Planning Committee

Edinburgh BioQuarter and South East Wedge Parkland: Finalised Masterplan

Item number 7.1

Appendix 1 - Edinburgh BioQuarter and South East Wedge Parkland Non-statutory Masterplan — draft for consultation — schedule of responses May 2014

Key Diagram

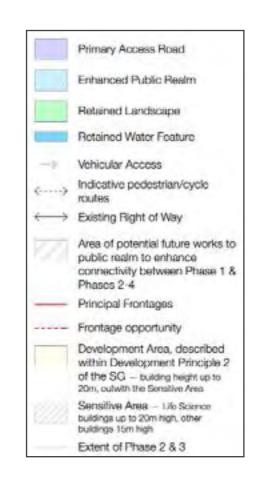
Welcome the approach taken to the management of the historic environment assets within the South East Wedge/proposed parkland area, including the scheduled home farm.	Noted.
Scotways	 Two rights of way (LC90 / LC91) Concerned that neither of the rights of way appear on key diagram (p.6). Both routes should be clearly marked on Masterplan. Continuing access should be permitted during construction, even if temporary diversions are required for safety or practical reasons. While LC90 follows the line of a public road, the key diagram marks it for traffic coming from New Greendykes as 'public transport vehicles' only, which seems to preclude other public access. Post construction works, this route should be signposted to confirm that cyclists are also permitted to use it. While other pedestrian cycle routes are indicated on diagram, they do not appear to provide access to the same areas as the rights of 	Rights of Way (LC90/LC91) have been marked on the key diagram (page 6 of the masterplan).

- The key diagram on page 6 does not appear to reflect the full extent of proposed development as portrayed elsewhere within the draft masterplan document. SUDS will constitute development and the SUDS strategy diagram shows proposals for off-site features of an uncertain scale or form. SNH have concerns that the SUDS requirements could be extensive and may adversely affect the size and quality of the park and the wider active travel provision that it will provide.
- Suggest that a precise boundary is drawn to the developable area and that the form and function of land use proposals is suitably colour coded.
- Concerned that the draft Masterplan shows the proposed 'frontage opportunity' in a location some 50m further north than shown in the SG.

Not agreed. A precise boundary highlighting the developable area with colour coding to indicate the form and function of land use proposals would be too prescriptive at this masterplan stage.
